DESIGN REQUIREMENTS

UNIVERSITY OF UTAH SUPPLEMENT

August 1, 2019 SF

DATE	PAGE NO.	SECTION	SUMMARY OF APPROVED CHANGE
<u>8/29/18</u>	<u>12</u>	<u>3.1 N</u>	<u>Added requirements for Small Wireless Facilities</u>
<u>8/1/19</u>	<u>31</u>	<u>3.3 D (2)</u>	<u>Minor changes to Joint Sealants</u>
<u>8/1/19</u>	<u>85</u>	<u>3.5 H (3)</u>	<u>Removed specific Clock System product</u>
<u>8/1/19</u>	<u>86-87</u>	<u>3.5 H (5)</u>	<u>Minor changes to Fire Alarm System requirements</u>
<u>8/1/19</u>	<u>196, 201</u>	<u>6.2</u>	<u>Minor updates for specific products and vendors</u>

F.E. Exterior Insulation & Finish Systems (EIFS)

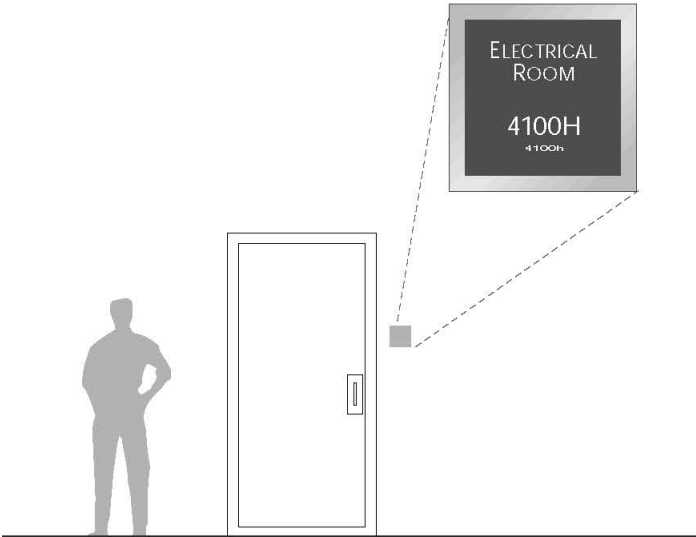
- ~~(1) The application of EIFS systems is not allowed on campus. Portland cement stucco may be considered if a recommendation for its use is submitted to the University early in the design of a building. The use of stucco on campus buildings is generally discouraged.~~

~~(4) Metal Fabrications~~

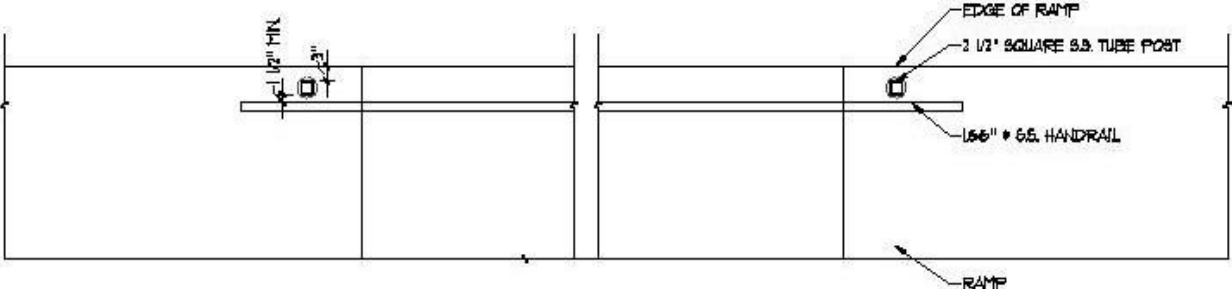
- ~~a. All ferrous metal fabrications designed for exterior exposure shall have all surfaces galvanized after fabrication. Painting for these items will need to address the problems associated with galvanized metal.~~

- g. Handrail Details

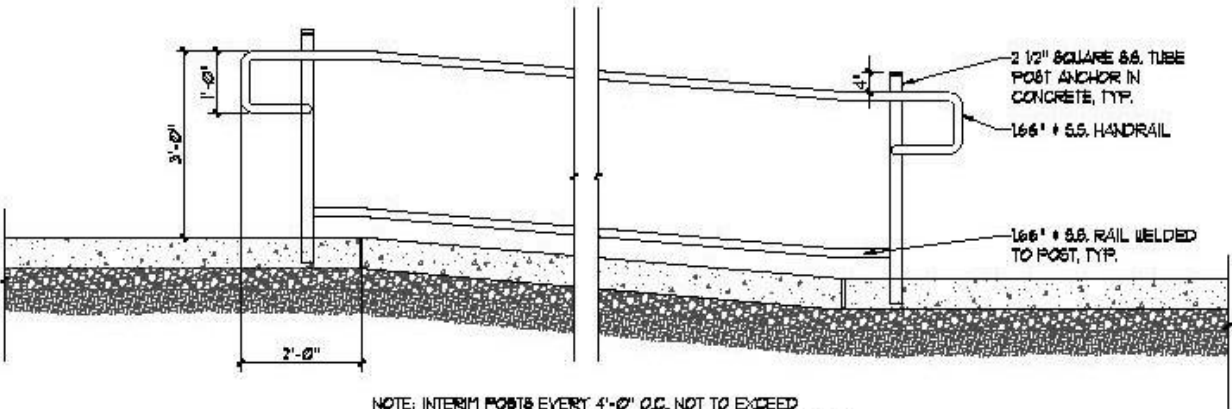
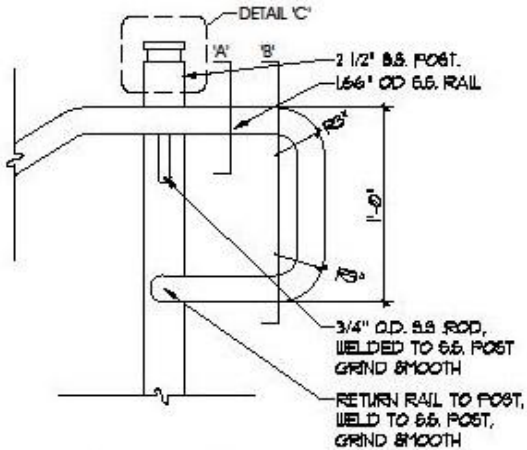
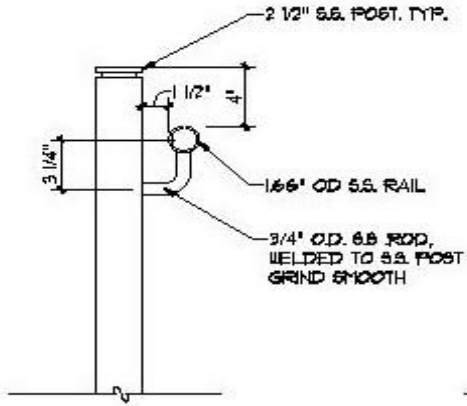
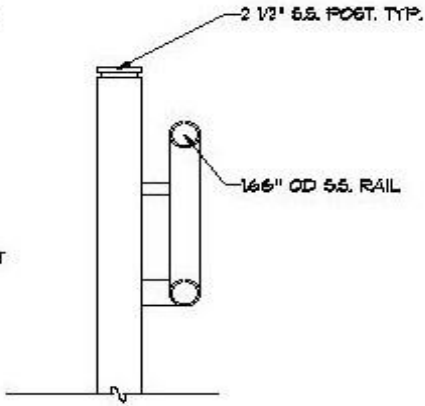
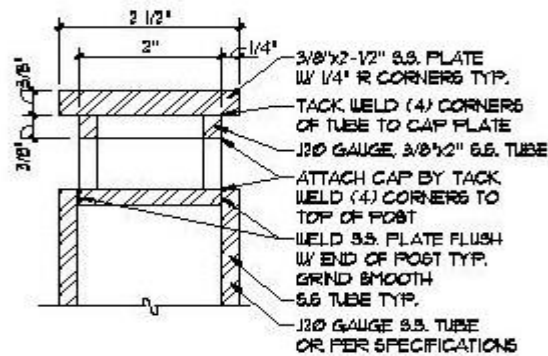
- ~~ii. Provide handrail extensions beyond vertical posts as required by code and return to vertical posts 12-in below top of handrail. Use 3-in radius bends at handrail changes of direction. See detail below.~~

- ii. Anchor 1.66-in diameter stainless steel handrails to posts with .75-in diameter stainless steel rods, welded both ends.
 - ~~iii. Provide handrail extensions beyond vertical posts as required by code and return to vertical posts 12-in below top of handrail. Use 3-in radius bends at handrail changes of direction.~~

- ~~iv. Provide Anti-Skateboard post caps as described above. Set posts in core drilled holes as described above. Provide handrail extensions per code and return handrail ends to posts. See detail below.~~
